# Memorandum

**SUBJECT: PDC05-114. PLANNED DEVELOPMENT REZONING FROM CO(PD) COMMERCIAL OFFICE PLANNED DEVELOPMENT, LI LIGHT INDUSTRIAL, AND CG COMMERCIAL GENERAL ZONING DISTRICTS TO A(PD) PLANNED DEVELOPMENT ZONING DISTRICT TO ALLOW UP TO 460 MULTI-FAMILY ATTACHED RESIDENCES AND UP TO 20,000 SQUARE FEET FOR RETAIL COMMERCIAL USES ON A 2.4 GROSS ACRE SITE, LOCATED ON THE SOUTHWEST CORNER OF NORTH FIRST STREET AND CENTURY CENTER COURT (1731 AND 1733 NORTH FIRST STREET) (JAMES SCHMIDT ET AL, OWNER).**

**PDC05-114**  
**DRAFT DEVELOPMENT STANDARDS**  
**REVISED AS PER PLANNING COMMISSION DIRECTION**  
**8-22-2007**

FIGURE 1 - SJC APM: EXISTING ALIGNMENT  
SOUTH SIDE OF CENTURY CENTER COURT

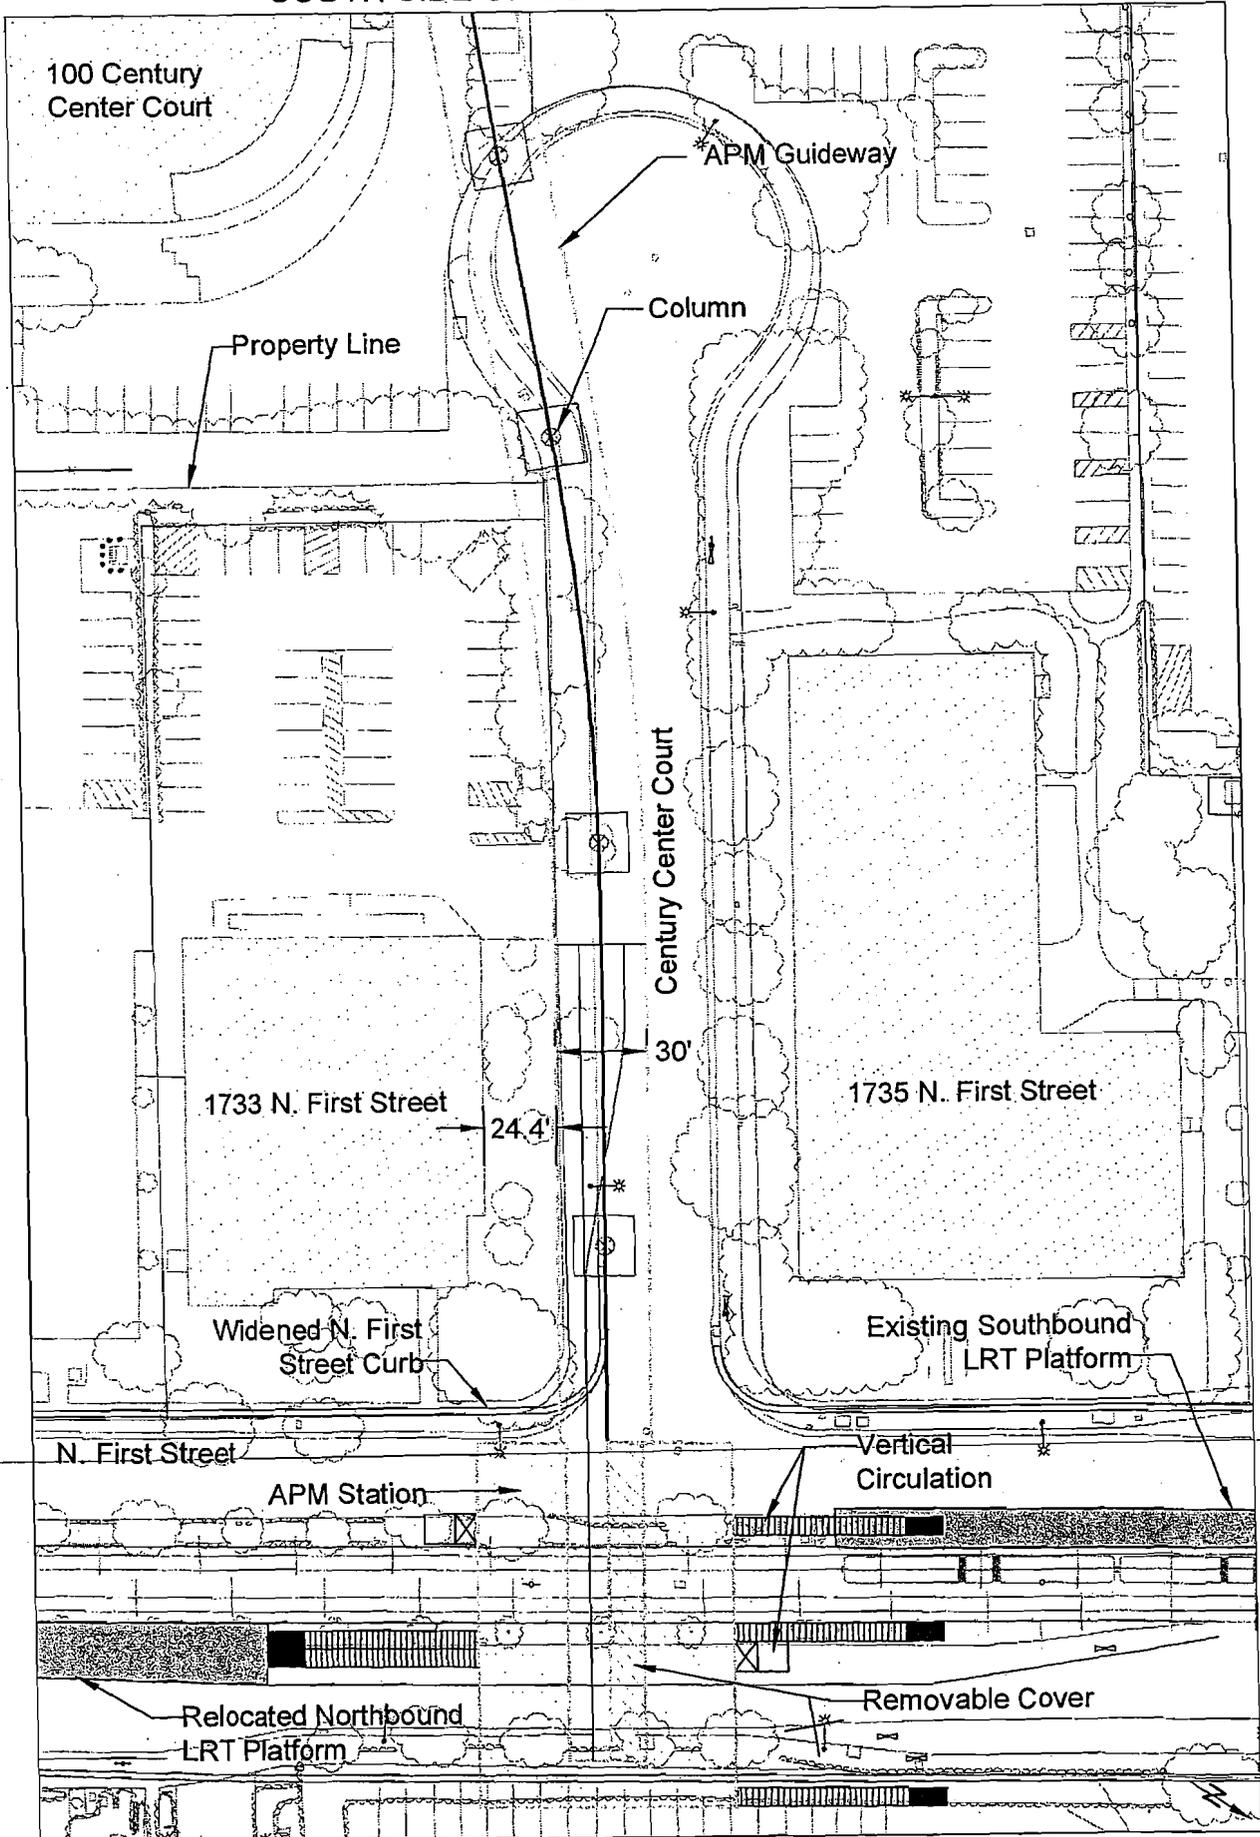
Recently, a developer began the permitting process for a new building at 1731/1733 N. First Street. However, the planned APM along the south side of Century Center Court impacts the developer's plans. Lea+Elliott was tasked to perform a conceptual study to determine the following:

**FIGURE 2 - SJC APM: ALTERNATIVE ALIGNMENT  
NORTH SIDE OF CENTURY CENTER COURT**

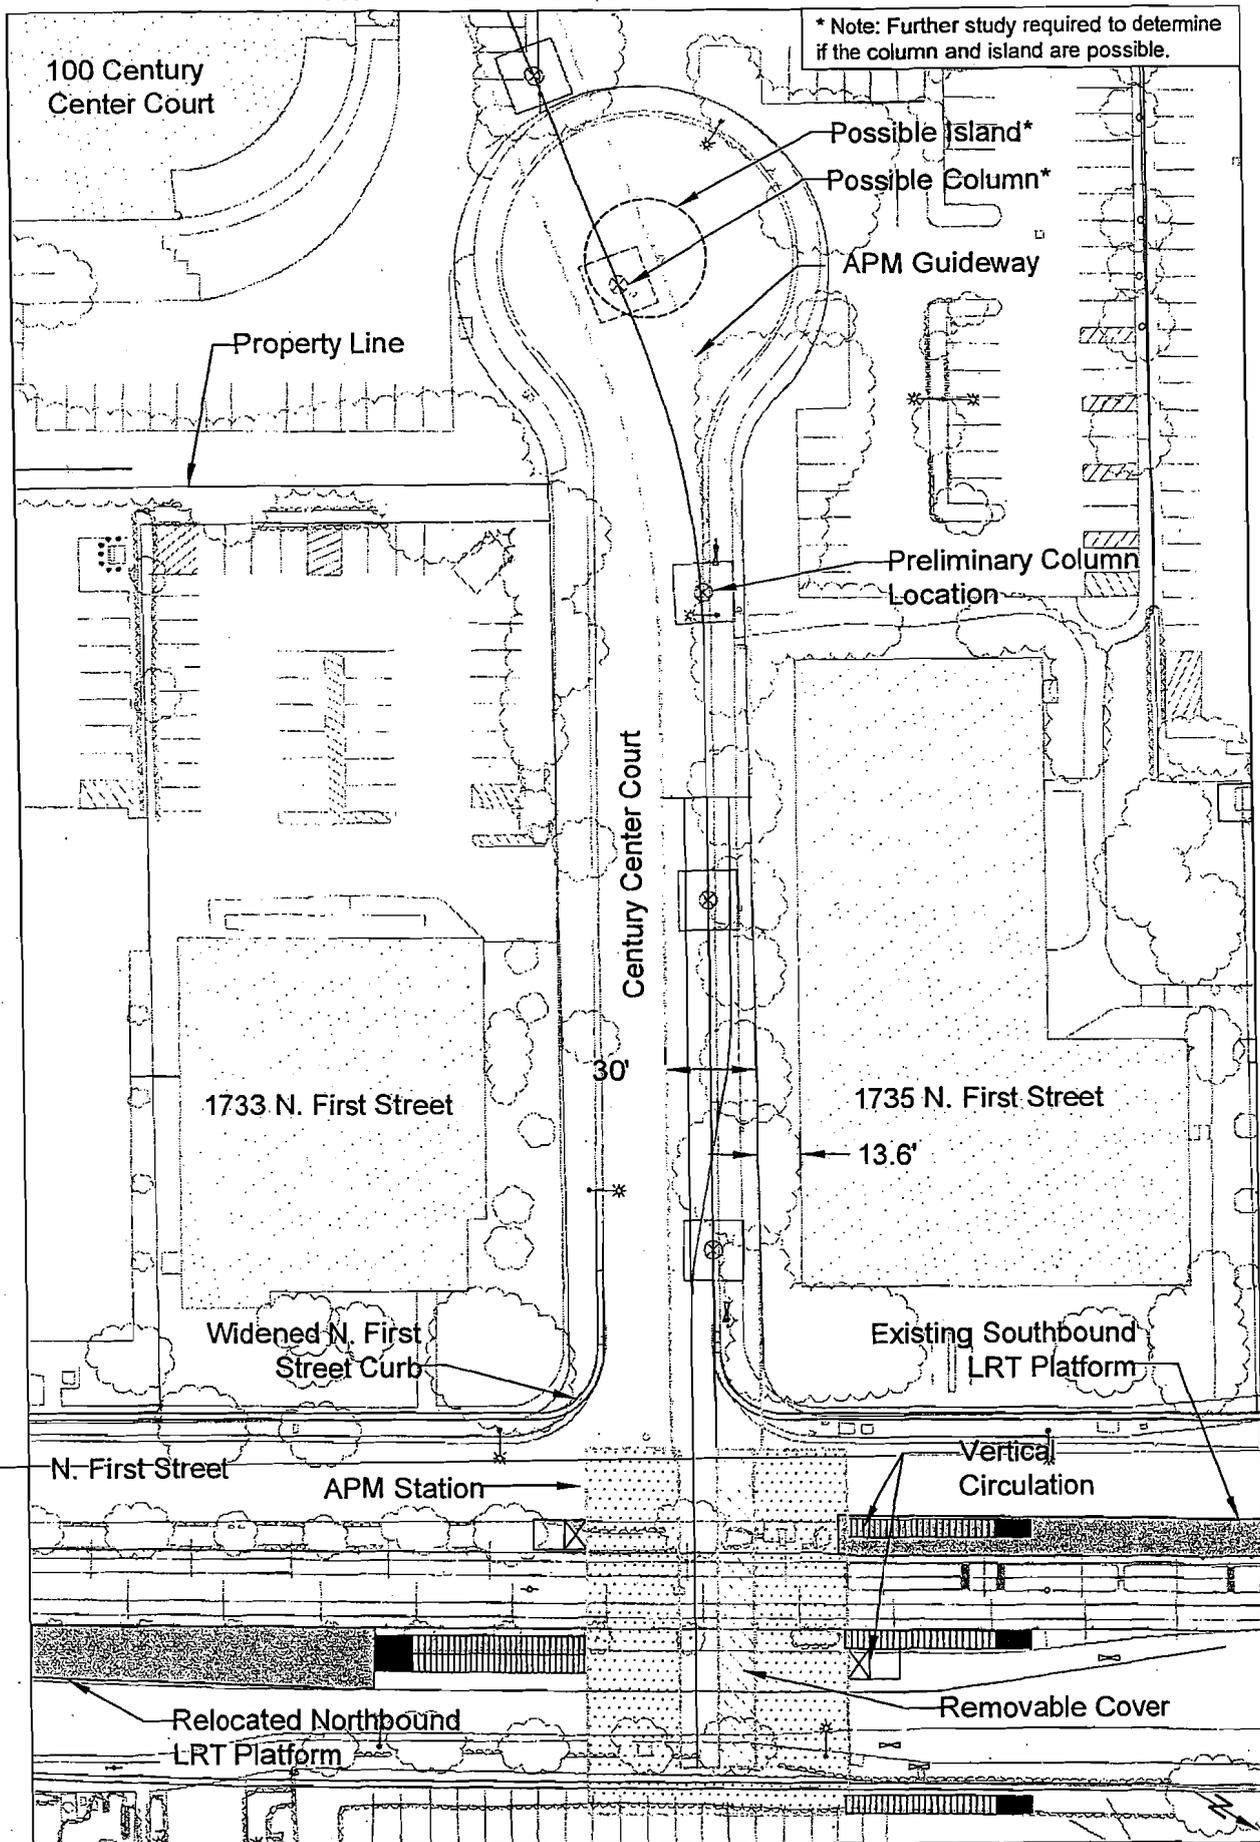
1. It is feasible to shift the APM alignment to the north side of Century Center Court. The proposed alternative alignment is depicted in Figure 2, which is located at the end of this report. However, this alternative APM alignment has the following impacts to the project:
  - The vertical circulation between the APM and the southbound LRT stations now touches down in the LRT train's berthing position. This may result in the need to widen the LRT platform and hence require additional widening of N. First Street.
  - A potential column and island in the middle of Century Center Court cul-de-sac. The feasibility of this column and island needs to be confirmed with the City of San Jose (CSJ).
  - An increase in cost of approximately \$500,000, exclusive of the cost due to potential additional widening of N. First Street discussed in the first bullet above.

The alternative APM alignment crosses the Century Center Court cul-de-sac, as depicted in Figure 2. The resulting long curved span of elevated guideway would be less costly with the addition of a column on a new island in the cul-de-sac. However, this island may pose traffic and/or safety issues. Further study and discussions with the CSJ are suggested to determine if this option is feasible.
